This amendment revises portions of Technical Specifications 2.1.1 and 3.1.7 and their Bases to reflect new methodology in establishing Maximum Average Planar Linear Heat Generation Rates (MAPLHGR); to reflect the Maximum Total Peaking Factor and MAPLHGR limits for a new fuel type; and to change exposure-dependent Minimum Critical Power Ratio (MCPR) limits to one limit that is applicable to the entire cycle.

Amendment No. 97
License No. DPR-63

AMENDMENT NO. 97 TO FACILITY OPERATING LICENSE NO. DPR-63

SAFETY EVALUATION BY THE OFFICE OF NUCLEAR REACTOR REGULATION
RELATED TO AMENDMENT NO. 97 TO FACILITY OPERATING LICENSE NO. DPR-63
NIAGARA MOHAWK POWER CORPORATION
NINE MILE POINT NUCLEAR POWER STATION, UNIT NO. 1
DOCKET NO. 50-220

FIGURE 2.1.1 FLOW BIASED SCRAM AND APRM ROD BLOCK

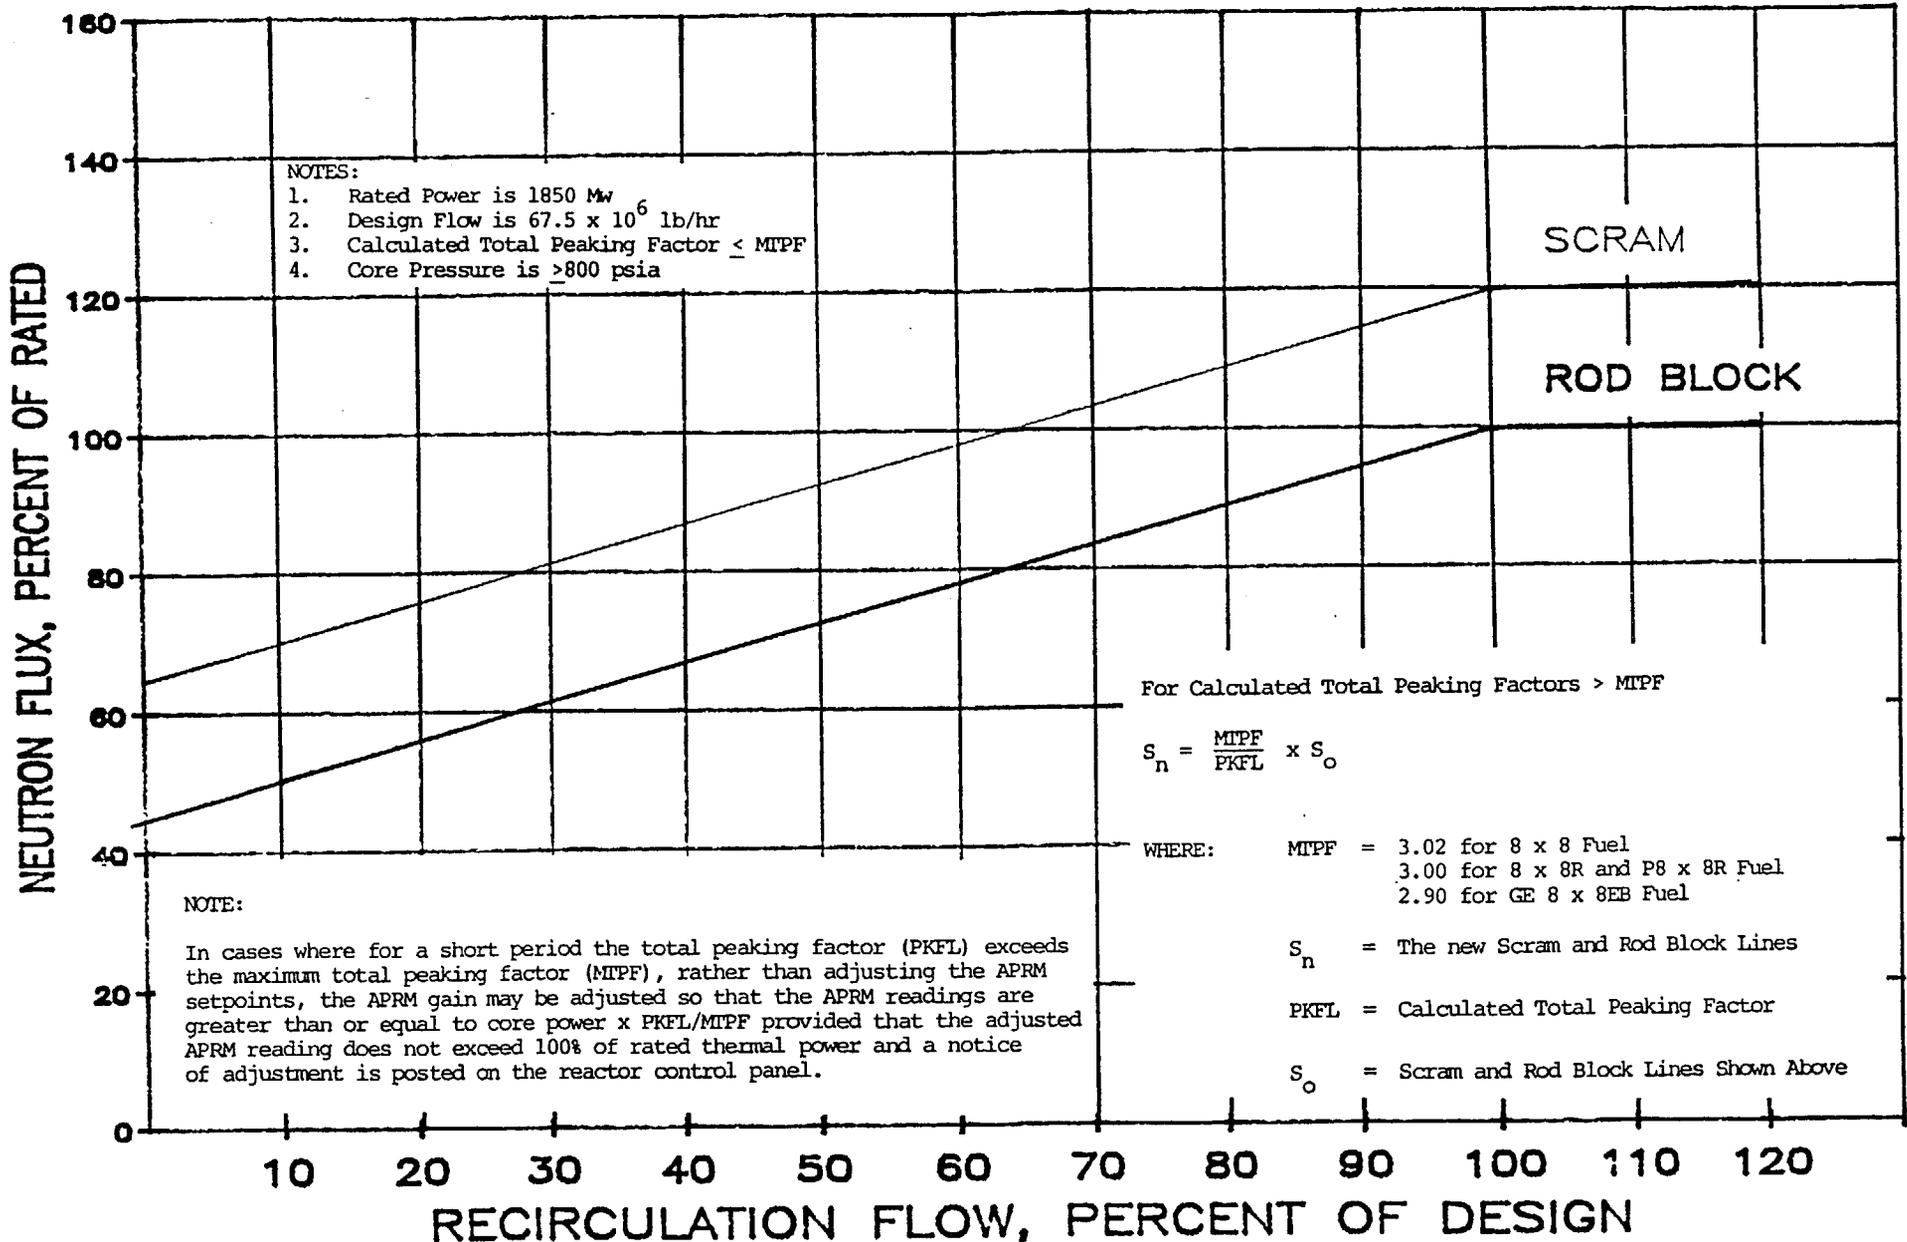
In addition to the boiling transition limit SLCPR operation is constrained to a maximum LHGR of 13.4 kW/ft for 8x8, 8x8R, P8x8R and GE8x8EB fuel (Reference 15). At 100% power, this limit is reached with a Maximum Total Peaking Factor (MTPF) of 3.02 for 8x8 fuel, 3.00 for 8x8R and P8x8R fuel, and 2.90 for GE8x8EB fuel. During steady-state operation where the total peaking factor is above 2.90, the equation in Figure 2.1.1 will be used to adjust the flow biased scram and APRM rod block set points.

1) Specification 2.1.1, Bases 2.2.1 and Figure 2.1.1 - Changes include the formula contained in Figure 2.1.1 for adjusting the flow biased scram and APRM rod block setpoints in those cases where the calculated total peaking factor exceeds the maximum total peaking factor for the fuel type, specifically the GE8x8EB is the new fuel to be added to the core during the 1988 refueling and maintenance outage. The maximum total peaking factor for the GE8x8EB fuel was calculated by GE to be 2.90. This change has been clarified in the note of Figure 2.1.1, which reads: in cases where for a short period the total peaking factor (PKFL) exceeds the maximum total peaking factor (MTPF), rather than adjusting the APRM setpoints, the APRM gain may be adjusted so that the APRM readings are greater than or equal to core power X PKFL/MTPF provided that the adjusted APRM reading does not exceed 100% of rated thermal power and a notice of adjustment is posted on the reactor control panel. We find that this revision provides needed flexibility during startup and power escalation to rated conditions and is acceptable. Due to addition of new fuel GE8x8EB, a 2.9 maximum total peaking factor (MTPF) for GE8x8EB fuel was included in Bases 2.1.1. We find this to be acceptable. Addition of Reference 15 to References for Bases 2.1.1 and 2.1.2 is acceptable. This Reference 15 is a letter from C. Thomas (NRC) to J. Charnley (GE) dated May 28, 1985, "Acceptance for Referencing of Licensing Topical Report NEDE-24011-P-A, Amendment 10."

Figure 3.1.7f Maximum Allowable Average Planar LHGR Applicable to P8DRB299 and Future Reload Fuel as described in Reference 15.

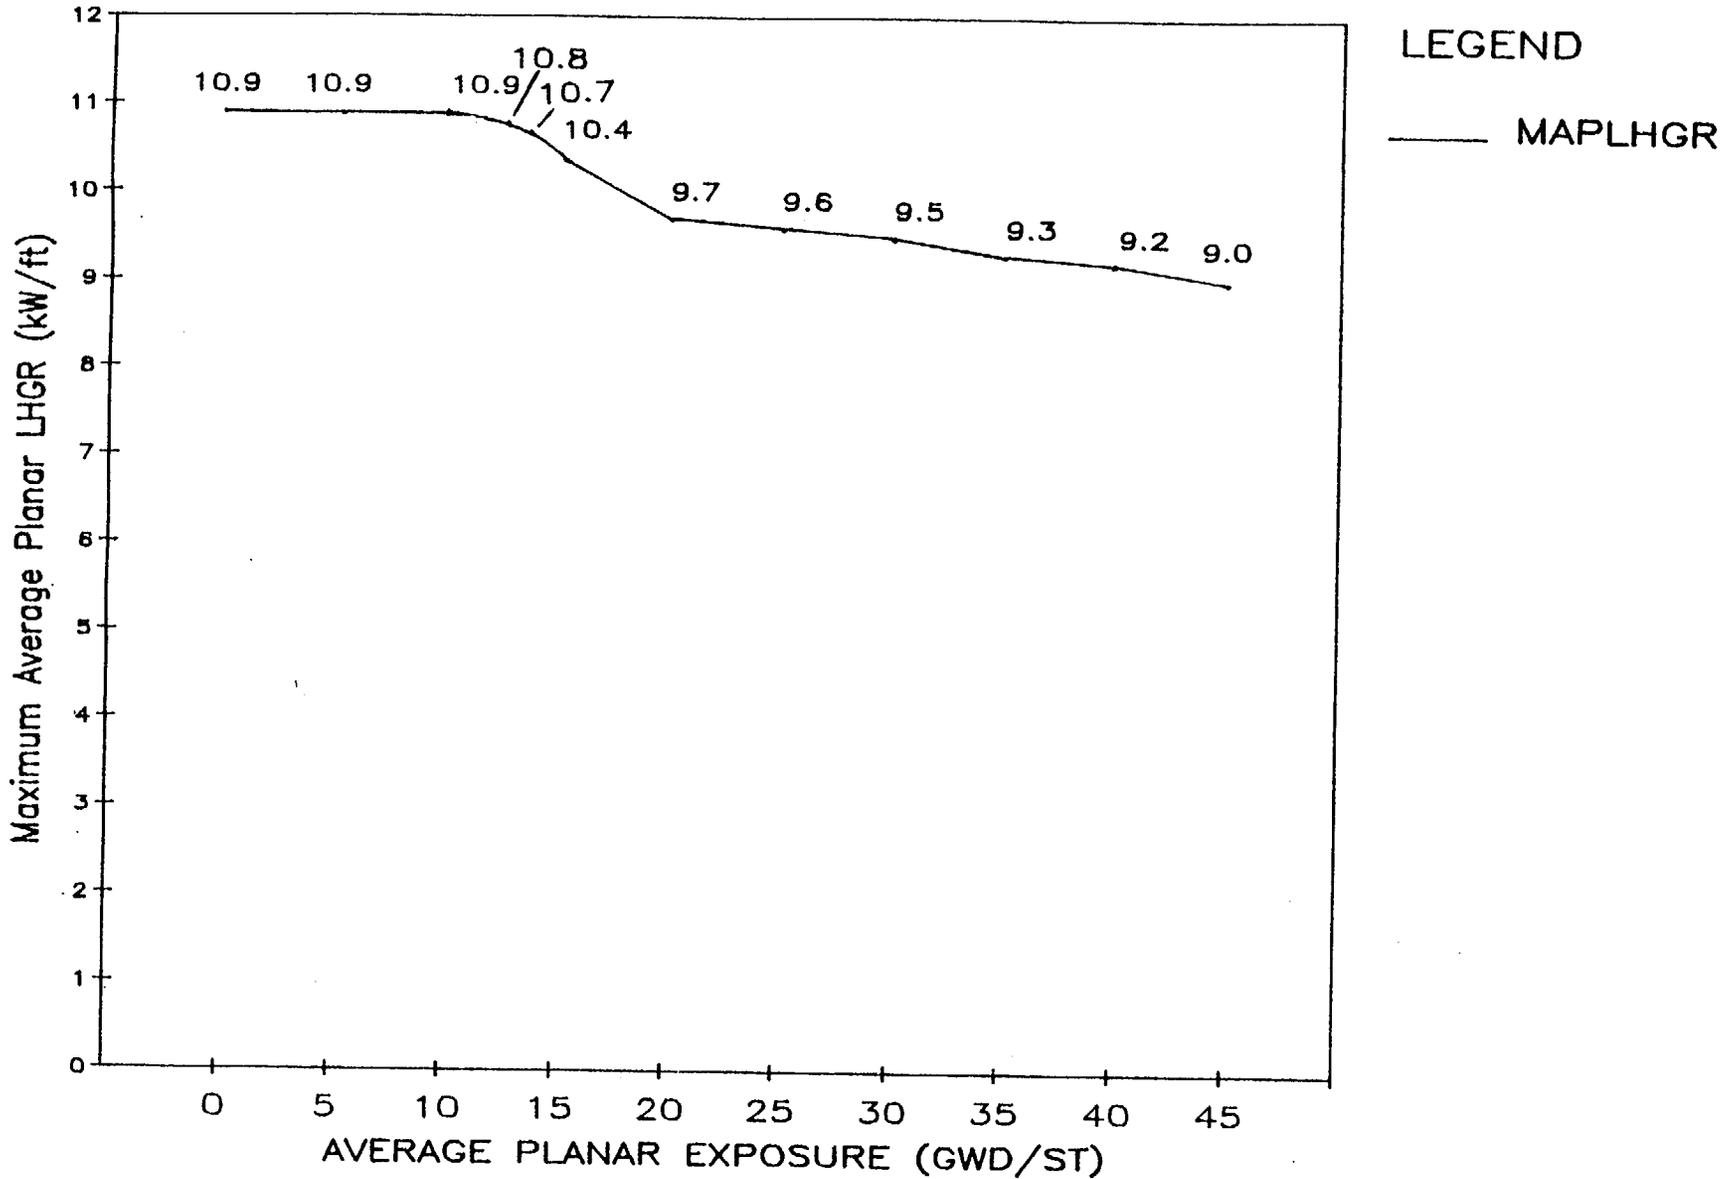
The licensee has proposed that two MAPLHGR curves for the fresh fuel bundles of BD321B (Figure 3.1.7g) and P8DRB299 (Figure 3.1.7f) be added to the NMP-1 Cycle 10 Technical Specifications. These MAPLHGR curves are generated based on the approved methodology (Ref. 5) and the results, which conform to 10 CFR 50 Appendix K requirements and meet 10 CFR 50.46 criteria, are given in References 4a and 4b. We find these changes are acceptable.

2) Specification 3.1.7, Bases 3.1.7 and 4.1.7 and Figures 3.1.7f and 3.1.7g - The proposed changes to Specification 3.1.7 and the addition of Figures 3.1.7f and 3.1.7g reflects the use of the SAFER/CORECOOL/GESTAR-LOCA computer codes and methodology (Ref. 4b) and the addition of maximum average planar linear heat generation rate (MAPLHGR) limits for the GE8x8EB fuel. The methods used to analyze the loss of coolant accident response of P8DRB299 and GE8x8EB fuel conform to 10 CFR 50 Appendix K requirement and were approved by the staff (Ref. 5). Therefore, the changes are acceptable. The results of the limiting transients (Ref. 3) indicate that if a minimum critical power ratio of 1.37 is maintained throughout the cycle, it will assure that the minimum critical power ratio will not go below 1.07 during the most limiting transient. The
